TECHNICAL BULLETIN
Bell Helicopter **TEXTRON**

No. 205-04-115

SUBJECT: TRANSMISSION OIL PUMP 212-040-184-001,
MODIFICATION OF.

FIGURE 1

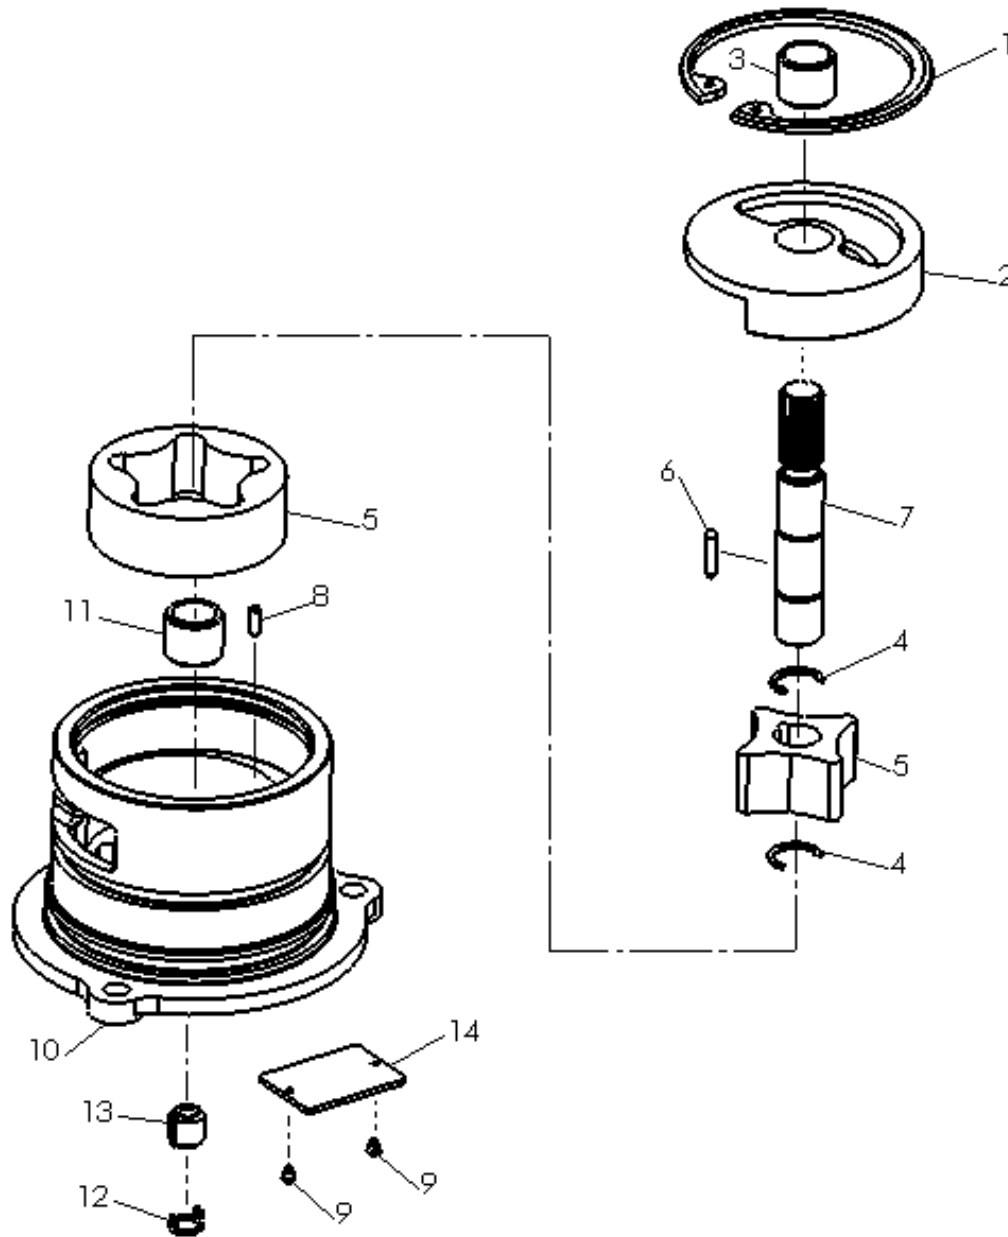
Bell Helicopter has investigated some instances where mechanical damage was noticed on the oil pump shaft P/N 35-79501-0007-1 and key P/N 35-56017-0038-1.

This bulletin introduces a modification to the transmission oil pump P/N 212-040-184-001. The modification consists of an improved shaft, inner gerotor and cylindrical key. The part number of the modified pump is 212-040-184-101.

1. Disassemble pump in accordance with instructions given in BHT-205A1-CR&O, Chapter 66.
2. Discard retainers (4, Figure 1), gerotor assembly (5), key (6), and shaft (7).
3. Clean and inspect remaining pump components in accordance with instructions given in BHT-205A1-CR&O, Chapter 66.
4. Based on inspection results, replace all discrepant parts.

Parts discarded per Item 2 above are not interchangeable with new parts. Do not attempt to re-use any parts discarded per Item 2 in a 212-040-184-101 oil pump.

5. Refer to Table 1 for the configuration of the oil pump 212-040-184-001 or -101.
6. Re-assemble oil pump in accordance with instructions given in BHT-205A1-CR&O, Chapter 66.
7. Re-identify oil pump as follows:
 - a. With a vibrating stylus scribe part number 212-040-184-101FM and serial number on the new Nameplate (use the same serial number on the new Nameplate).
 - b. Remove and discard old Nameplate.
